PZ&B Staff Combination Memorandum: Town Council and Architectural Commission

SUBJECT: ARC-23-094 (ZON-23-072) 241 WORTH AVE (COMBO)

MEETING: JANUARY 24, 2024 ARCOM
FEBRUARY 14, 2024 TOWN COUNCIL

Original Submission

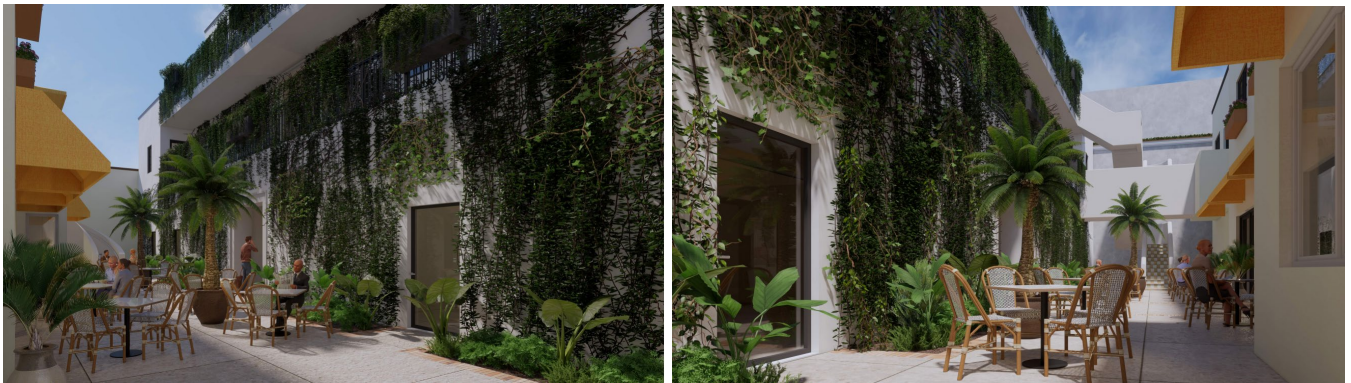
The applicant is now proposing a more substantial restoration of the front façade of the existing building within all bays, the applicant does intend on initially modifying the westernmost bay (Brioni) to recall aspects of the original design in the re-introduction of the fluted art deco pilasters.

With that, the two-story addition takes many of the design cues from the original Art Deco design, most notably in the rhythm and the breakdown of the bays. The rear of the new construction consists open two upper levels of open-air walkways and catwalks as well as two new egress stairs with a vertical metal picket style railings. This rear façade shall not be visible from the right-of-way of across from the Peruvian Ave parking lot. However, while not a primary or secondary façade, the applicant has made considerable efforts to refine and improve this “rear facade”. There are two existing curvilinear stairs (that do not meet today’s code requirements for life safety) within the courtyard that provide access to the second floor of Le Bilboquet. These features are proposed to be demolished in order to address code compliant life safety and egress requirements as determined by the Fire Marshal. It must be noted that the applicant made numerous attempts to salvage both of these decorative features, but in the end, has managed to retain one of the stairs.

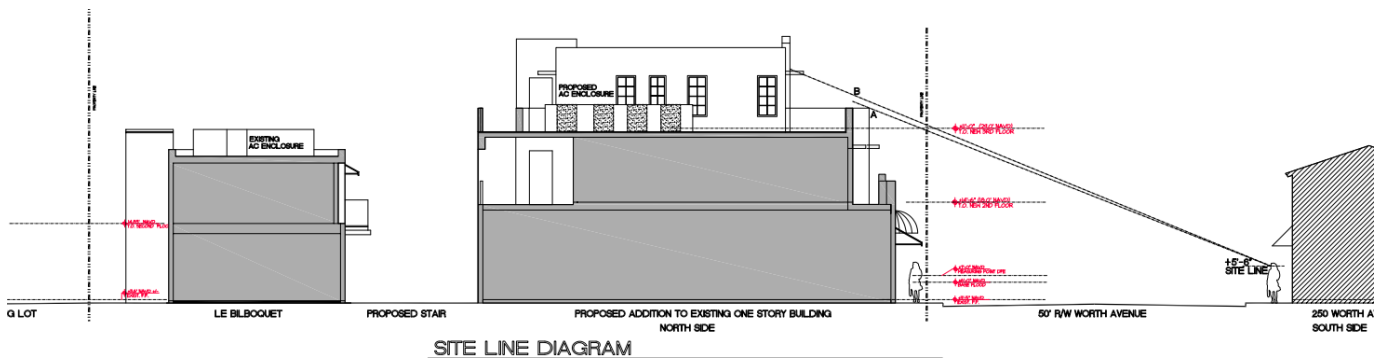
VARIANCE #4 [Sec. 134-2211\(a\)](#): Variance from the required minimum number of off-street loading spaces provided on-site. For new construction of commercial buildings between 4,000 SF and 25,000 SF of new area, one (1) on-site loading space is required. The new additions total 7,145 SF of new square footage to the 12,200 SF site.. The GIS map below illustrates the designated commercial loading zones, indicated in red, along Worth Avenue. As such, there are currently two dedicated on-street loading spaces for the 200 block of Worth Avenue, located to the south of the subject property.

Currently, the site has admittance for deliveries, trash pick-up and grease trap access through a cross-access easement from the owner of the Apollo parking lot that abuts the property to the north. If the variance is granted, staff recommends conditioning the approval on the same as well as specifying hours.

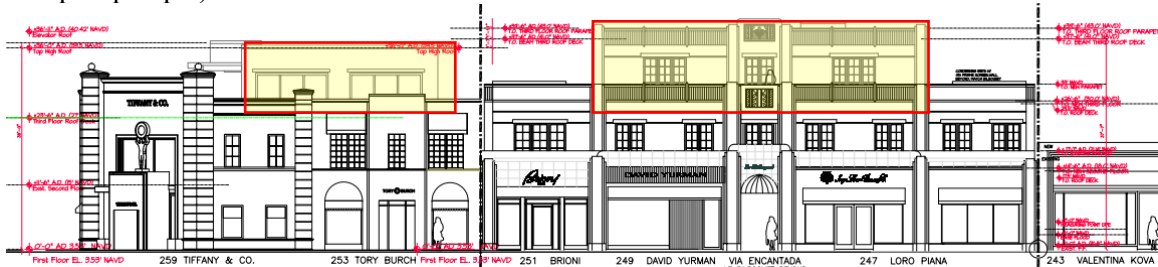
For comparison, the neighboring two-story building abutting the property to the west (the Tiffany building) received TC approval at the Nov 13, 2019 meeting for a special exception with site plan review and variance application in order to construct a third story as a special allowance based on the Worth Avenue Design Guidelines. That proposal consisted of a proposed third story with an enclosed 2,390 square feet of living space and active habitable roofdeck. The variance for the 720 square foot pergola which would allow a maximum third story coverage of 33% in lieu of the 25% lot coverage maximum allowed for a third story using the Worth Avenue Design Guidelines, pursuant to Z-19-00225. The ARCOM portion of that combo project was approved, pursuant to B-070-2019. That project (the Tiffany rooftop addition) was approved with a height of 36'-0" to the top of the third

floor roof (39.5 NAVD). This project is proposed at 39'-6" to the top of the third floor roof (43'-0" to top of parapet).

An enlarged elevation showing the second and third floor proposal as it relates to the abutting property to the west.

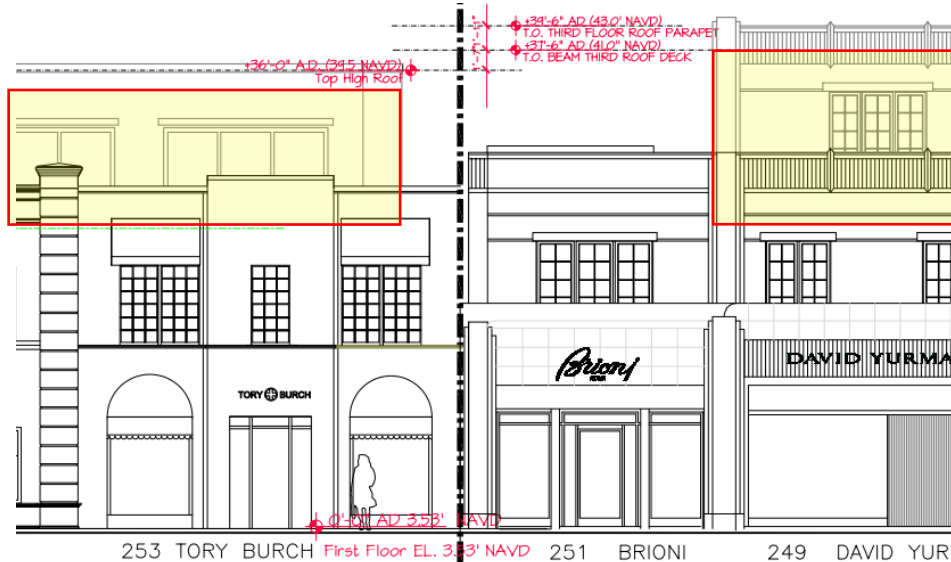
The third story residential unit is setback further from the street than the addition below as to not overwhelm the Avenue or alter the prevailing character. There is an opportunity to increase the front setback of the third story addition and push the mass further back from the street, which reduces the area of the outdoor rear north terrace.
